REVIEW OF THE REVISED
MILLSTONE UNIT 3 PROBABILISTIC SAFETY STUDY
SEISMIC FRAGILITY

Prepared for

Lawrence Livermore National Laboratory

May 4, 1984

FIGURE 2-1. MILLSTONE RESPONSE SPECTRA FOR 10% DAMPING

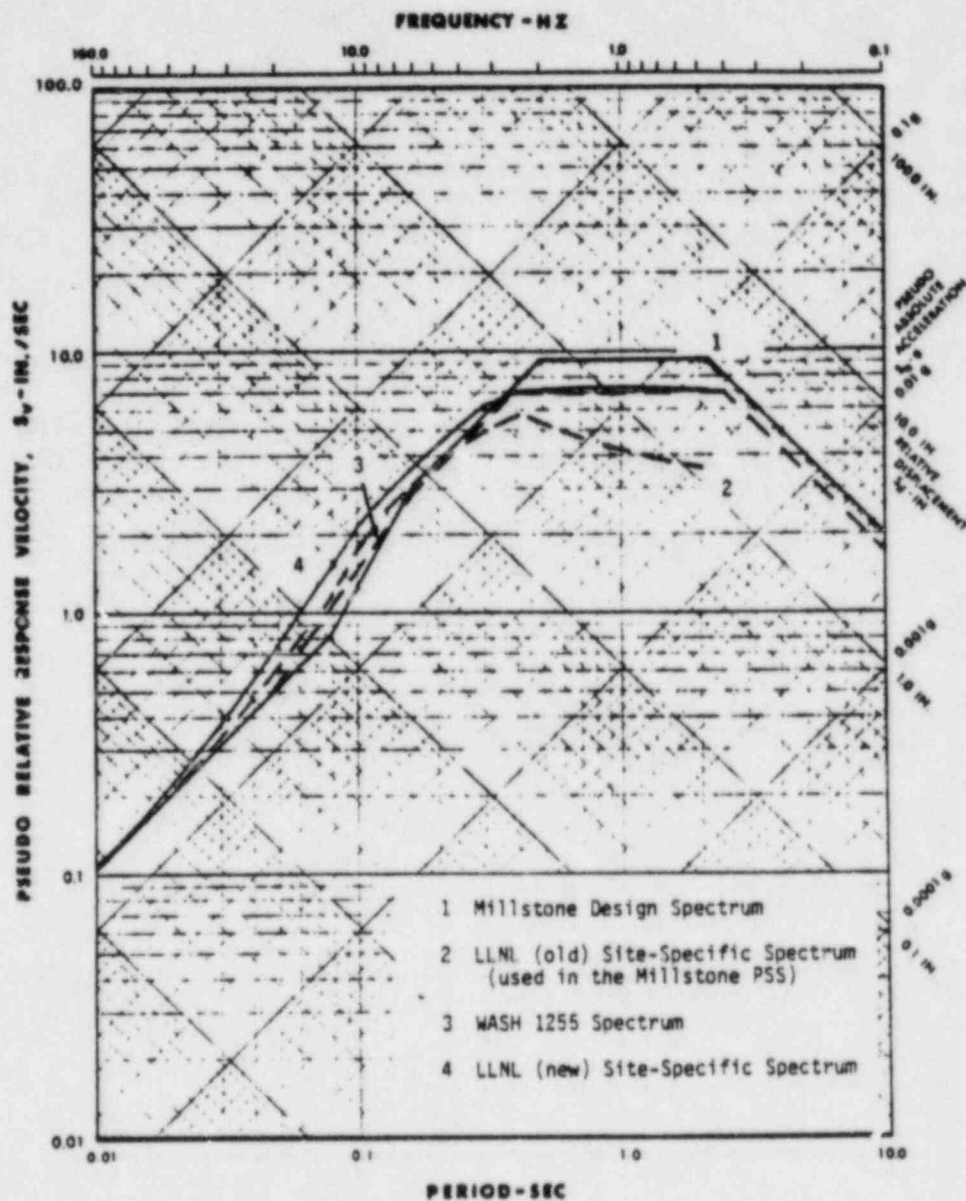
The response spectrum shape for earthquake magnitudes in the range 5.3 to 6.3 developed in Reference 11 for rock sites was used. Figure 2-1 shows this spectra with the Millstone design spectra for 10 percent damping. The procedure described in Reference 11 to convert the 5 percent damped spectrum to 10 percent damping was used. Each spectrum in the figure is scaled to 0.17g, the SSE level. Also shown in the figure is the WASH 1255 broad-band response spectrum.

In addition to these spectra, LLNL (Ref. 13) has conducted a new seismic hazard analysis for the Millstone site. In Figure 2-1, the 1000 year return period spectral shape scaled to 0.17g is shown.

Based on the comparison in Figure 2-1 we find that the magnitude-dependent spectra are generally higher than the design spectra for frequencies greater than 5 Hz. Among these, the most recent spectra developed by LLNL has the highest spectral level. At frequencies less than 5 Hz, the design spectrum exceeds the site-specific spectrum, with the greatest variations occurring at frequencies less than 2 Hz.

In comparison to the WASH 1255 broad-band spectra, the LLNL site-specific spectra both have higher spectral levels at frequencies beyond 5 Hz. In the 2-5 Hz region, the WASH 1255 is higher.

4. The NRC should determine if the site-specific spectrum used in the fragility analysis is appropriate. See Table 2-1 and Figure 2-1 for a comparison of different response spectra.
